April 18, 2016

Re: Review of Responses to Fox April 4, 2016 Comments on Valero's Appeal of Planning Commission's Denial of Valero Crude-by-Rail Project

Figure 1: Originated Class I Carloads of Crude Oil, 2008-

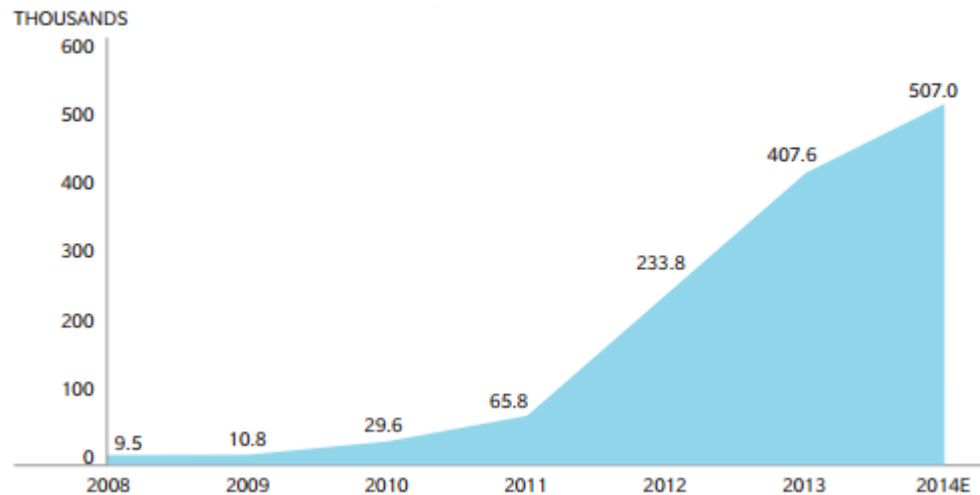
Third, sizeable shipments of crude oil in unit trains started only around 2011, in response to new shale crude discoveries in the midcontinent that were not connected to market by pipeline. This is demonstrated by Figure 1, which shows a dramatic rise in crude oil shipped by rail, starting around 2011. Mr. Radis relies on statistics for the 15 year period 2000 to 2015, which misleads because only 4 years out of this 15-year record included significant unit train crude transport and unloading. Four years of data is simply inadequate to determine accident probabilities for a terminal that will operate for at least 30 years.

Figure 2: Comparison of Tank Release Points Modeled in Radis Figure 1 with Tanks that Would Store Rail-Imported Crude Oil (red crosshatched area Fig. 2a).

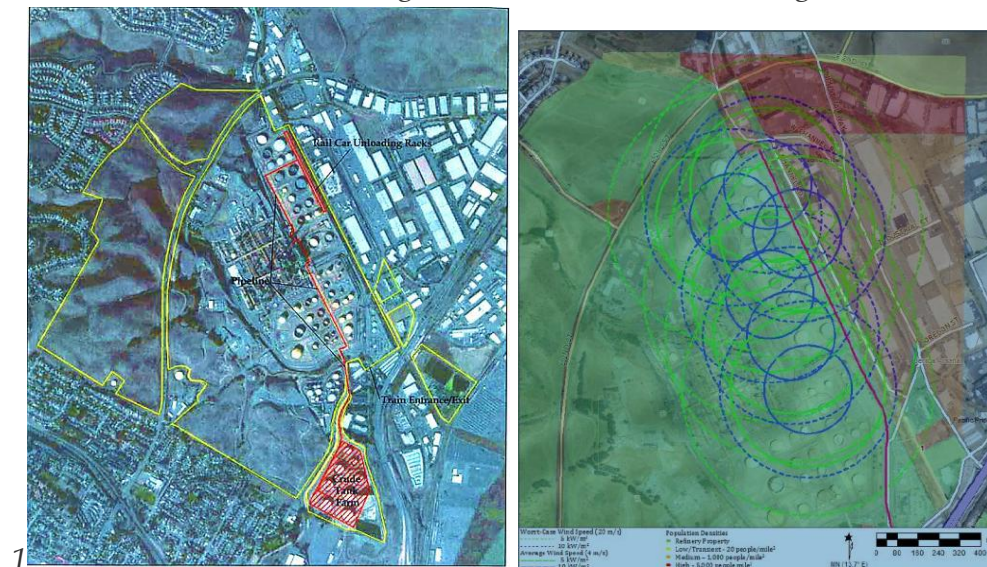
However, none of these four tank locations are near those where the rail-imported crude oil would be stored (Tanks 1701-1708). The tanks that would store rail-imported crude (1701-1708) are southwest of the area shown on Radis Figure 1, reproduced below as Figure 2b. This unanalyzed release point is the closest to residential and other sensitive receptors, as shown in Figure 1 of my 4/4/16 comments, reproduced below as Figure 2a. The tank farm that would actually store the rail-imported crude oil was not analyzed in the EIR or in subsequently submitted responses to PRA requests. If it had been, off-site impacts would have been significant due to the proximity of sensitive receptors and the higher population density of residential areas.

Mr. Radis' Figure 1 simply moves the worst-case, on-site accident to different locations, without considering the changing conditions at those locations that would affect accident consequences. For example, an accident at a tank in the West Tank Farm could engulf several adjacent tanks, including LPG spheres, resulting in much greater consequences than the spill of 240,000 gallons of crude oil in the middle of the unloading rack. Thus, moving the worst-case rail spur accident centroid around in the West Tank Farm without performing a site-specific QRA for the specific impacted tanks is not relevant and does not constitute a tank accident analysis.

Finally, it is important to note that Radis Figure 1 (Fig. 2b above) was not included in the EIR and was submitted in response to a PRA request addressed in the

3/30/16 Radis letter.²⁵ The record contains no support for this figure nor discussion of its implications. My inspection of this figure indicates that it just moves the hazard zones for the same worst-case accident around the site and West Tank Farm, in an effort to support the selected location for the worst-case accident. However, the figure fails to include the true worst-case location, the actual tank farm where the crude oil would be stored, the red cross-hatched area in Figure 2a, located only 1,000 feet from a residential neighborhood. Further, if the worst case on-site accident occurred in the West Tank Farm, it could have much more severe consequences than the assumed on-site worst-case accident, located in the middle of the unloading rack, due to proximity of adjacent tanks.

Figure 2. Excerpts of FEMA Panel 634, 1/12/2015.

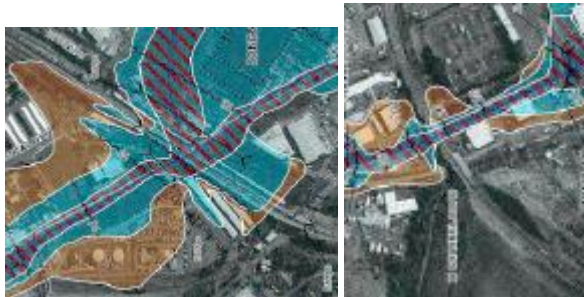
Fourth, available local tracks that could be used to reach higher ground may also be flooded, preventing escape. The southern track of the UP Mainline runs parallel with and close to the Bay shore. This southern track is used to access the refinery. East of Sulphur Springs Creek, the southern track of the UP Mainline is very low lying, at an elevation of only 1 ft crossing Lake Herman Road. East of Lake Herman Road, the northern and southern tracks of the UP Mainline converge and traverse Suisun marshland. The rail line in this area is already subject to unstable ground and flooding. The unstable ground can cause “dips” in the track, at which trains must slow down.⁴⁹

The excerpts from FEMA Panel 634 in Figure 2 show that rail lines leading into and out of the Project site would also likely be flooded.
